From: DaSilva, Luis [REDACTED]
Sent: 10 May 2018 13:24
To: Planning.Responses
Subject: planning application consultation - CM/7/18/PL

Your Ref
CM/7/18/PL
Our Ref
PLAN-022534
Date
10/05/2018

Proposal: Change of use of land from agricultural field to 60 No. tent pitches operating from April to October to include 2 No. plumbed screened portable showers, 2 No. plumbed portable toilets, 2 No. screened changing cubicles, 2 No. 2 screened portable chemical toilets with hand wash facilities & washing up/drying area within existing building.
Site: Woodpecker, Camping Field, Crookthorn Lane, Climping, BN17 5SN.
CM/7/18/PL

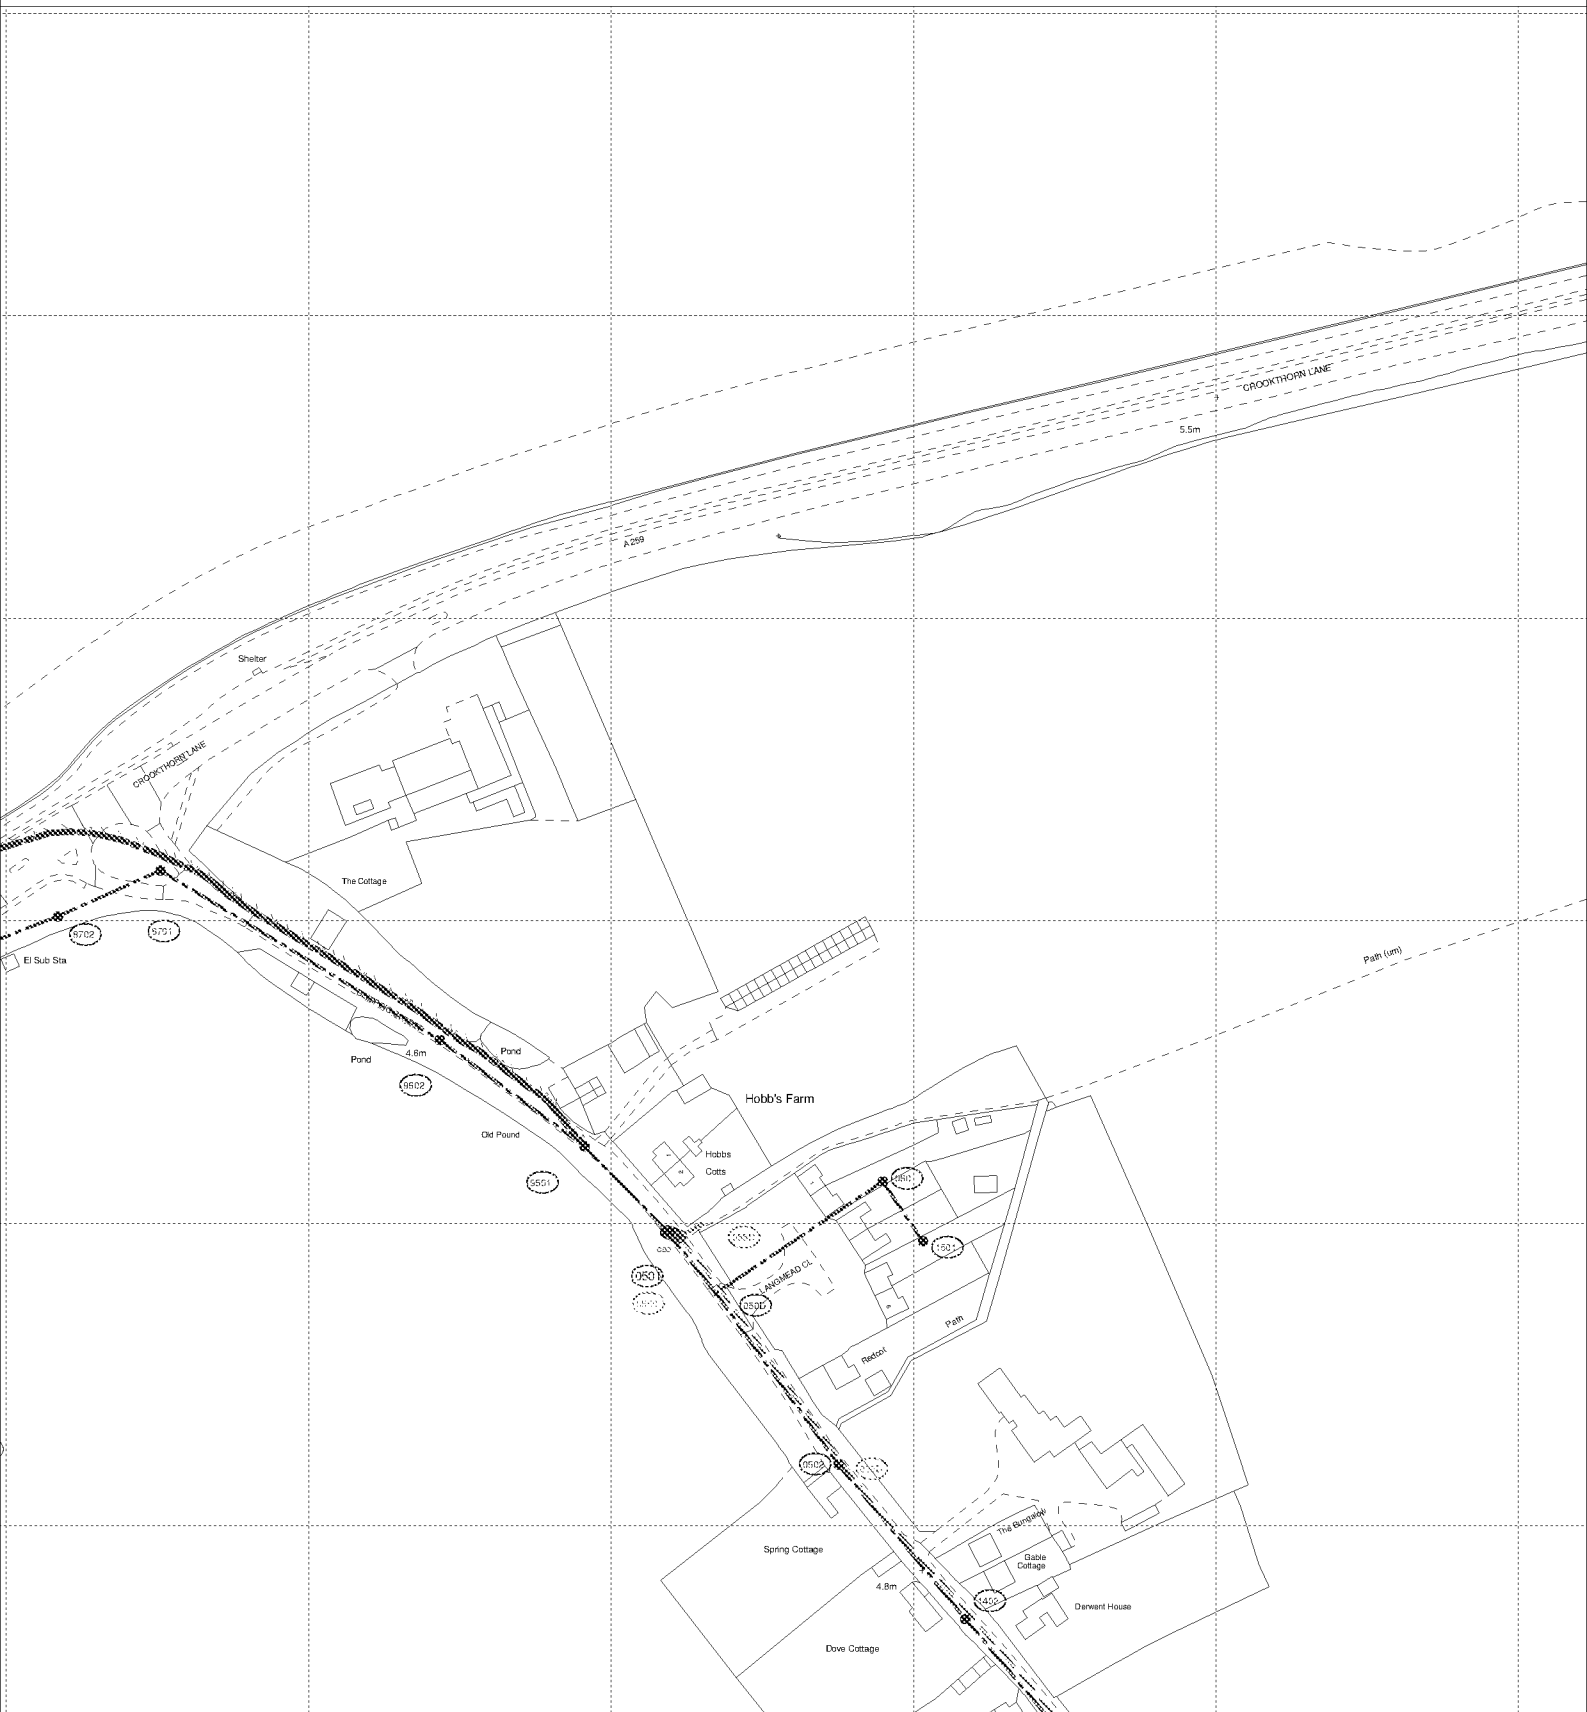
Due to surface water inundation issues in the Lidsey Catchment "The applicant is advised to adopt, where appropriate, the measures in the table "Practical measures to reduce the potential impacts of development".

Developer should look to protect the public sewerage system from inundation and infiltration, which contribute to flooding in unfavourable conditions.
